TRANS/WP.29/1018  
22 September 2004

**DRAFT 10 SERIES OF AMENDMENTS  
TO REGULATION No. 13**

(Braking)

ARRANGEMENTS OF APPROVAL MARKS

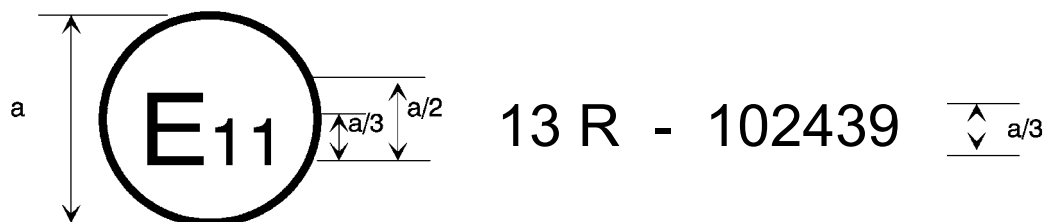
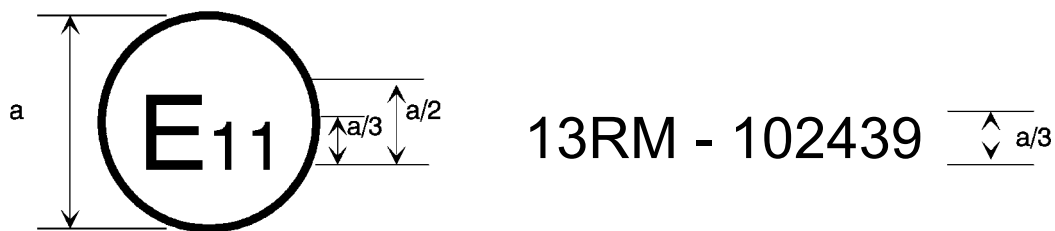
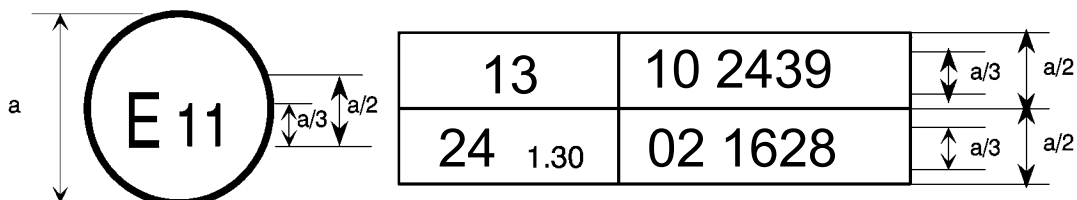
Annex 3, amend to read:

The above approval mark affixed to a vehicle shows that the vehicle type concerned has, with regard to braking, been approved in the United Kingdom (E 11) pursuant to Regulation No. 13 under approval number 102439. This number indicates that the approval was given in accordance with the requirements of Regulation No. 13 with the 10 series of amendments incorporated. For vehicles of categories M<sub>2</sub> and M<sub>3</sub>, this mark means that that type of vehicle has undergone the Type-II test.

The above approval mark affixed to a vehicle shows that the vehicle type concerned has, with regard to braking, been approved in the United Kingdom (E 11) pursuant to Regulation No. 13. For vehicles of categories  $M_2$  and  $M_3$ , this mark means that the type of vehicle has undergone the Type-IIA test.

The above approval mark affixed to a vehicle shows that the vehicle type concerned has been approved in the United Kingdom (E 11) pursuant to Regulations Nos. 13 and 24 1/. (In the case of the latter Regulation the corrected absorption coefficient is  $1.30 \text{ m}^{-1}$ .)

"DIAGRAM 2

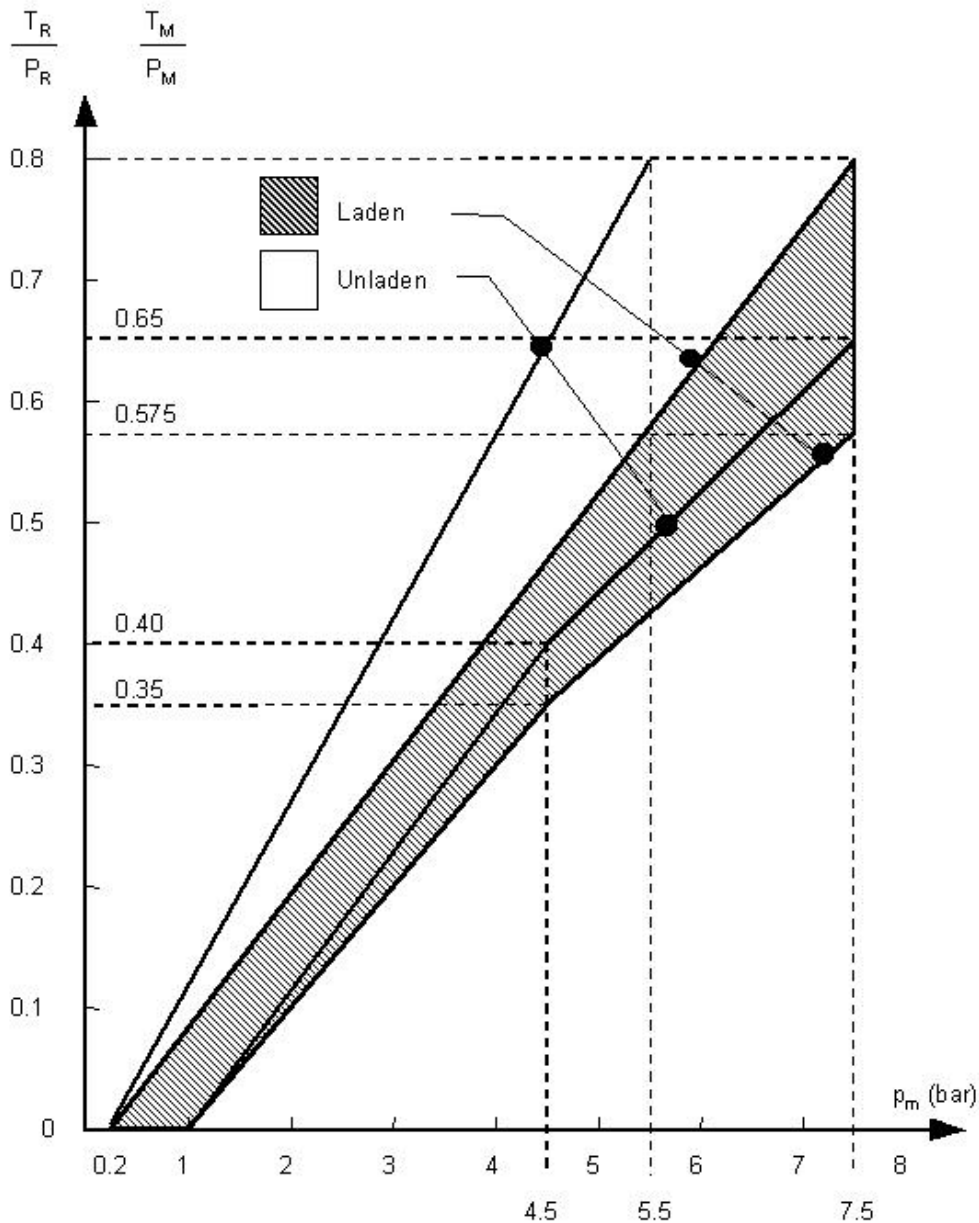
Diagrams 2, 3 and 4A, amend to read:

TOWING VEHICLES AND TRAILERS  
(except tractors for semi-trailers and semi-trailers)  
(see paragraph 3.1.5.1. of this annex)

Note: The relationships required by the diagram shall apply progressively for intermediate states of loading between the laden and the unladen states and shall be achieved by automatic means.
